RE: St. Lucie Nuclear Plant, Unit 1
Docket No. 50-335
Renewed Facility Operating License DPR-67

Supplement to Response to Requests for Additional Information (RAIs) Regarding St. Lucie Unit 1 License Amendment Request L-2024-200, Updated Spent Fuel Pool Criticality Analysis in Support of St. Lucie Unit 1 Transition to 24 Month Fuel Cycles

L-2026-086
Attachment 1

St. Lucie Unit 1, Technical Specifications Page Markups (revised)

INSERT 2

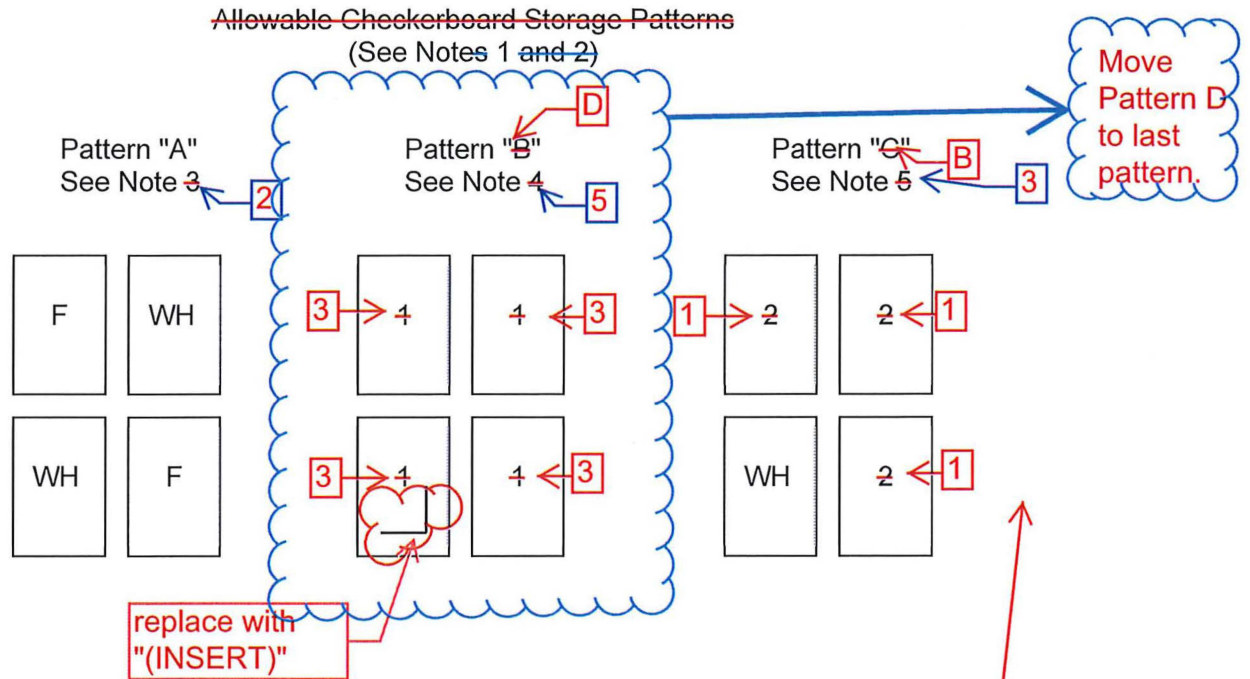
Replace Table with
INSERT 2

Replace with NOTE 2
from INSERT 2

Add new
NOTE 3
from
INSERT 2

Note 2: Linear interpolation of calculated burnups between cooling times for a given fuel assembly enrichment and a given fuel type is permitted.

Note 3: Fuel assemblies that experienced inserted CEA during the irradiation history, but where it can be demonstrated, based on operating records, that the burnup-weighted average CEA insertion depth is less than 20.19 cm from the top of the active length, are permitted for storage in the spent fuel cells with the minimum burnup requirement increased by 5 GWD/MTU. Fuel assemblies that experienced inserted CEA during the irradiation history, but where the burnup weighted average CEA insertion depth is more than 20.19 cm from the top of the active length, are only permitted for storage in the fresh fuel cells (i.e., Region 1 Pattern "A" and cask pit racks).

Figure 3.7.15-2 (page 1 of 2)
Allowable Region 2 Storage Patterns and Fuel Alignments

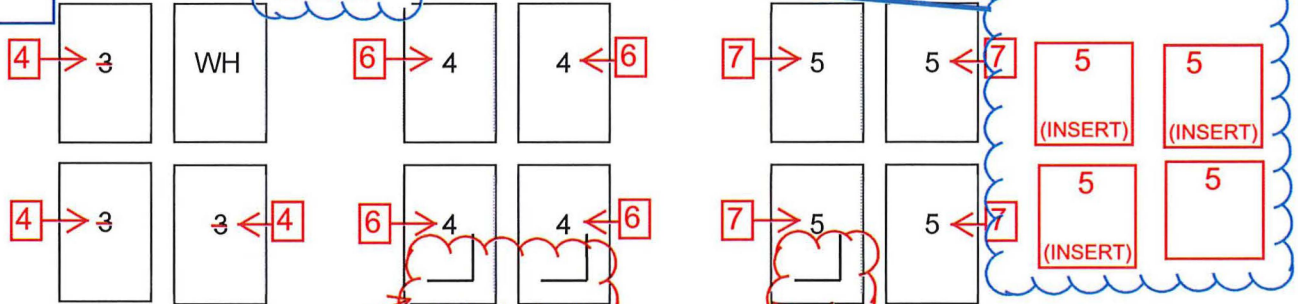
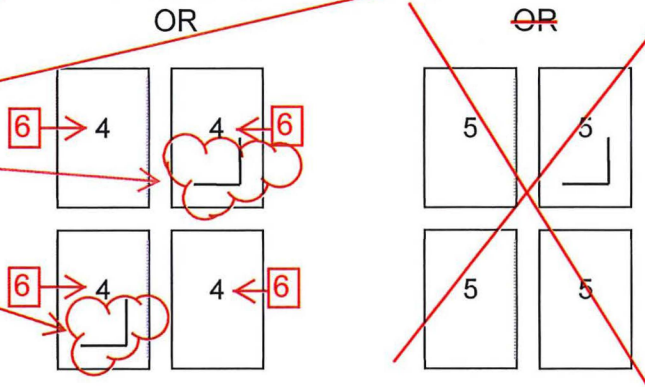
Add "Spent Fuel Assemblies in Region 2 Racks (See Note 2)"

Move Pattern F to this location

replace with "(INSERT)"

Relocate to top of page

2 → 4. The storage arrangements of fuel within a rack module may contain more than one pattern. Each cell is a part of up to four 2x2 arrays, and each cell must simultaneously meet the requirements of all those arrays of which it is a part.

3. Numbering denotes fuel assembly type. WH represents an empty cell. Minimum burnup for fuel assembly type 3 is defined in Table 3.7.15-1. Allowable pattern is at least one empty cell in any of the 2x2 array locations. Diagram is for illustration only.

5 → 4. Numbering denotes fuel assembly type. Minimum burnup for fuel assembly type 4 is defined in Table 3.7.15-1. Allowable pattern is at least two inserts, (either Metamic or full-length, full-strength CEA) in the 2x2 array. Diagrams are for illustration only.

6 → 5. Numbering denotes fuel assembly type. Minimum burnup for fuel assembly type 5 is defined in Table 3.7.15-1. Allowable pattern is one insert, (either Metamic or full-length, full-strength CEA) in the 2x2 array. Diagrams are for illustration only.

INSERT 3

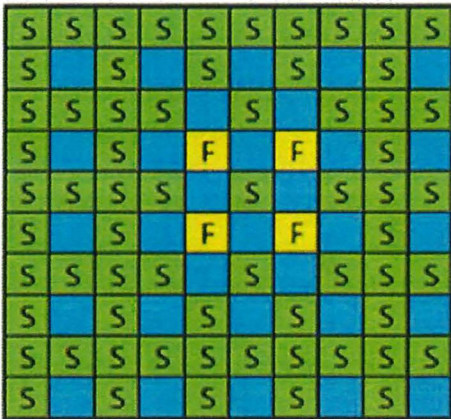
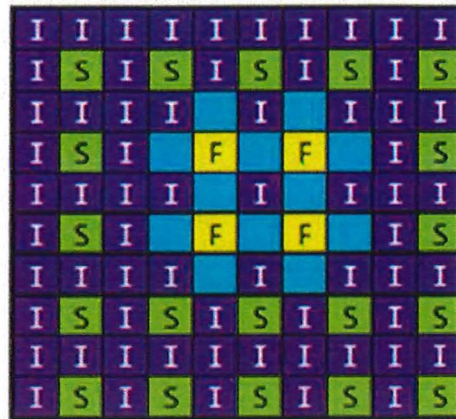
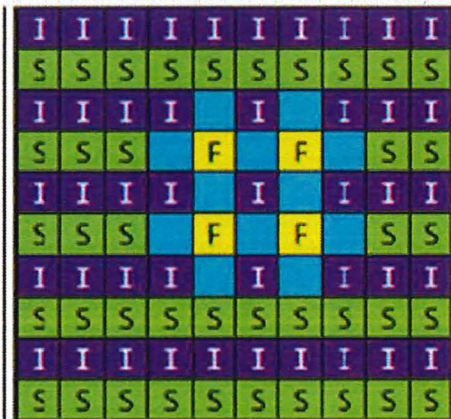
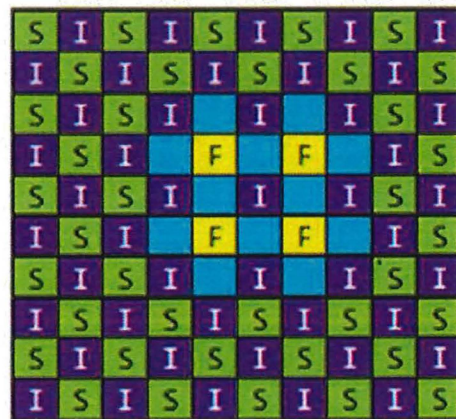
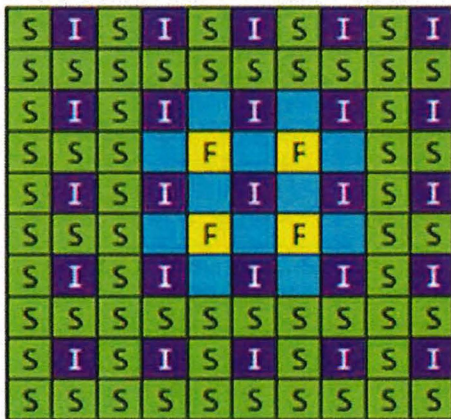
SR1. ~~Allowable pattern is up to four fresh or burned fuel assemblies placed in a 3x3 array in combination with Pattern E placed outside the 3x3 array. Fresh fuel shall be placed in the corners of the 3x3 array with completely water-filled cells placed face-adjacent on all sides. A fuel assembly that meets the requirements of type 4 shall be placed in the center of the 3x3 array. Minimum burnup for fuel assembly type 4 is defined in Table 3.7.15-1 as a function of maximum initial planar average enrichment. Diagram is for illustration only.~~

SR2. ~~Allowable pattern is up to four fresh or burned fuel assemblies placed in a 3x3 array in combination with Pattern F placed outside the 3x3 array. Fresh fuel shall be placed in the corners of the 3x3 array with completely water-filled cells placed face-adjacent on all sides. A fuel assembly that meets the requirements of type 5 with a Metamic insert or a full length, full strength 5-finger CEA shall be placed in the center of the 3x3 array. Minimum burnup for fuel assembly type 5 is defined in Table 3.7.15-1 as a function of maximum initial planar average enrichment and cooling time. Diagram is for illustration only.~~

SR3. ~~Allowable pattern is up to four fresh or burned fuel assemblies placed in a 3x3 array in combination with Pattern G placed outside the 3x3 array. Fresh fuel shall be placed in the corners of the 3x3 array with completely water-filled cells placed face-adjacent on all sides. A fuel assembly that meets the requirements of type 6 with a Metamic insert or a full length, full strength 5-finger CEA shall be placed in the center of the 3x3 array. Minimum burnup for fuel assembly type 6 is defined in Table 3.7.15-1 as a function of maximum initial planar average enrichment and cooling time. Diagram is for illustration only.~~

SR4. ~~Allowable pattern is up to four fresh or burned fuel assemblies placed in a 3x3 array in combination with Pattern H placed outside the 3x3 array. Fresh fuel shall be placed in the corners of the 3x3 array with completely water-filled cells placed face-adjacent on all sides. A fuel assembly that meets the requirements of type 7 with a Metamic insert or a full length, full strength 5-finger CEA can be placed in the center of the 3x3 array. Minimum burnup for fuel assembly type 7 is defined in Table 3.7.15-1 as a function of maximum initial planar average enrichment and cooling time. Diagram is for illustration only.~~

The 3x3 array is placed in combination with Pattern E.

The 3x3 array is placed in combination with Pattern F.

The 3x3 array is placed in combination with Pattern G.

The 3x3 array is placed in combination with Pattern H.

Figure 3.7.15-3 (page 1 of 2)
Region 2 Interface Requirements with Region 1

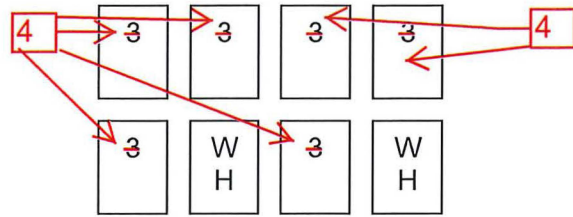
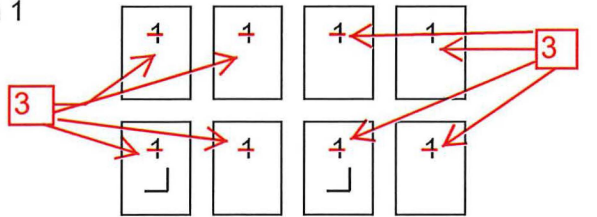
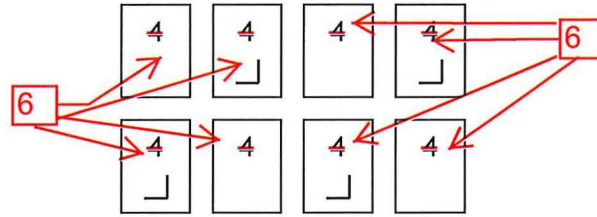
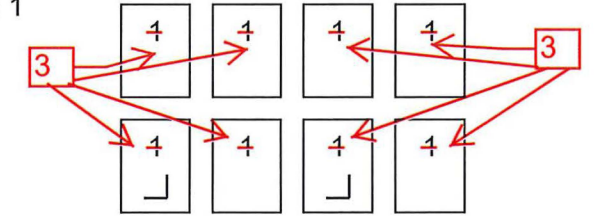
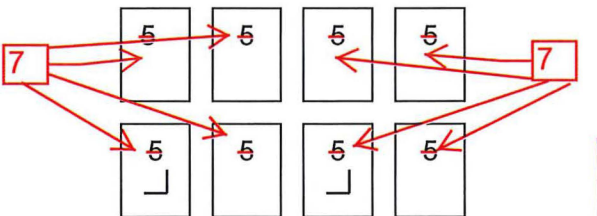
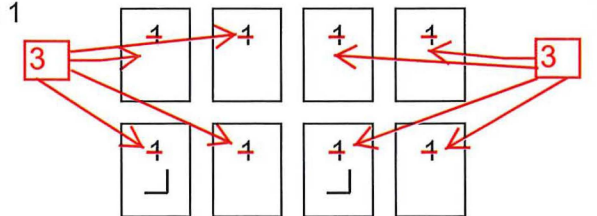
~~Allowed Region 2 to Region 1 Fuel Alignments~~
(See Notes 1 and 2)

Insert Pattern F (in
sequential order).

Add new
diagrams
from
INSERT 4

Relocate to
top of page

3. WH represents an empty cell. For the interface of Pattern "C" with Region 1, the empty cell must be on the rack periphery facing Region 1 racks. ~~Diagrams are for illustration only.~~ E is

- 5 5 → 4. For the interface of ~~Pattern~~ Pattern "D" with Region 1, at least one cell on the rack periphery facing Region 1 rack must contain an insert (either Metamic or full-length full-strength CEA) in the 2x2 array. If the insert is Metamic, the insert must be oriented so that the corner of the L-shape is located closest to the Region 1 rack. ~~Diagram is for illustration only.~~ G

- 6 6 → 5. For the interface of Pattern "E" with Region 1, the insert must be on the rack periphery facing the Region 1 rack. The insert may be either a Metamic or full-length full strength CEA. If the insert is Metamic, the insert must be oriented so that the corner of the L-shape is located closest to the Region 1 rack. ~~Diagram is for illustration only.~~ H

1. ~~Empty cells with any pattern are acceptable.~~ D
2. There are no interface requirements within Region 1. Any ~~Pattern~~ pattern within Region 1 may be used for the interface. Pattern "B" was used only as an illustration.

INSERT 4

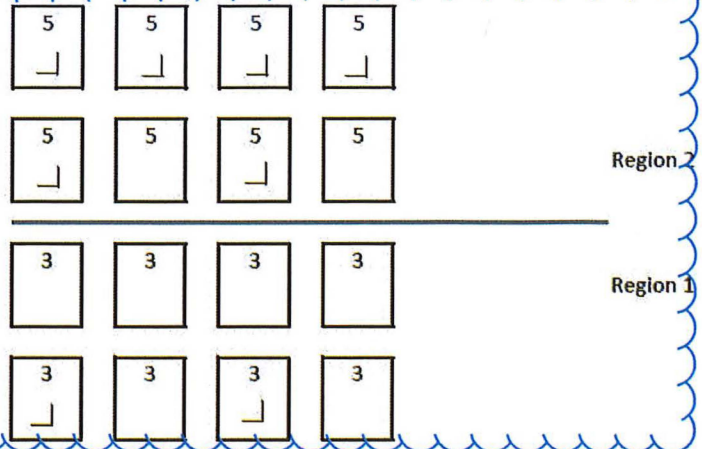
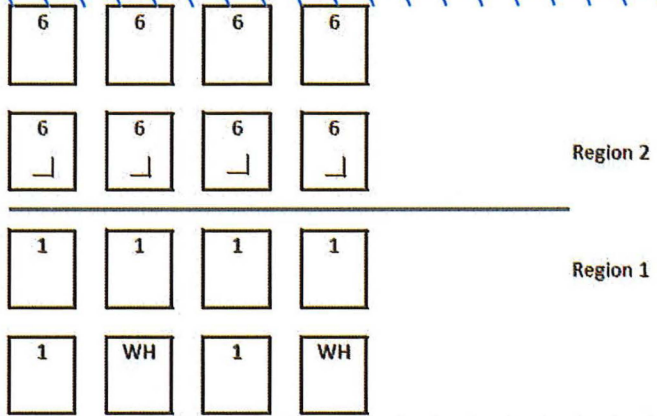
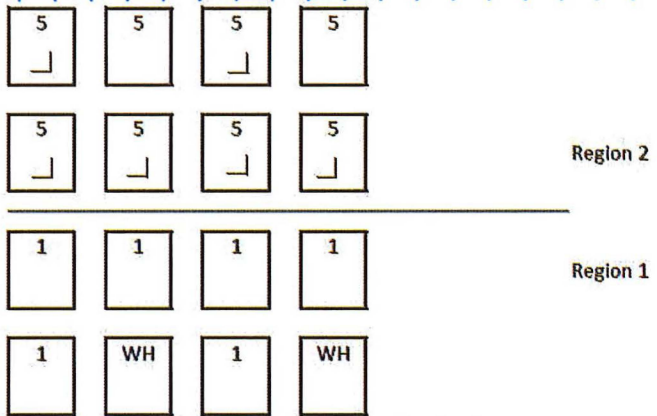
**Insert between
Patterns E and G**

**Swap these
two patterns**

4. For the interface of Pattern "F" with Region 1, at least one cell on the rack periphery facing Region 1 rack must contain an insert (either Metamic of full-length full-strength CEA) in the 2x2 array. If the insert is Metamic, the insert must be oriented so that the corner of the L-shape is located closest to the Region 1 rack. Diagram is for illustration only.
7. For the interface of Region 2 Patterns "F" and "G" with Region 1 Pattern "B", no less than two cells on the rack periphery facing Region 1 rack must contain inserts (either Metamic of full-length full-strength CEA) in the 2x2 array. If the insert is Metamic, the insert must be oriented so that the corner of the L-shape is located closest to the Region 1 rack. Diagram is for illustration only.
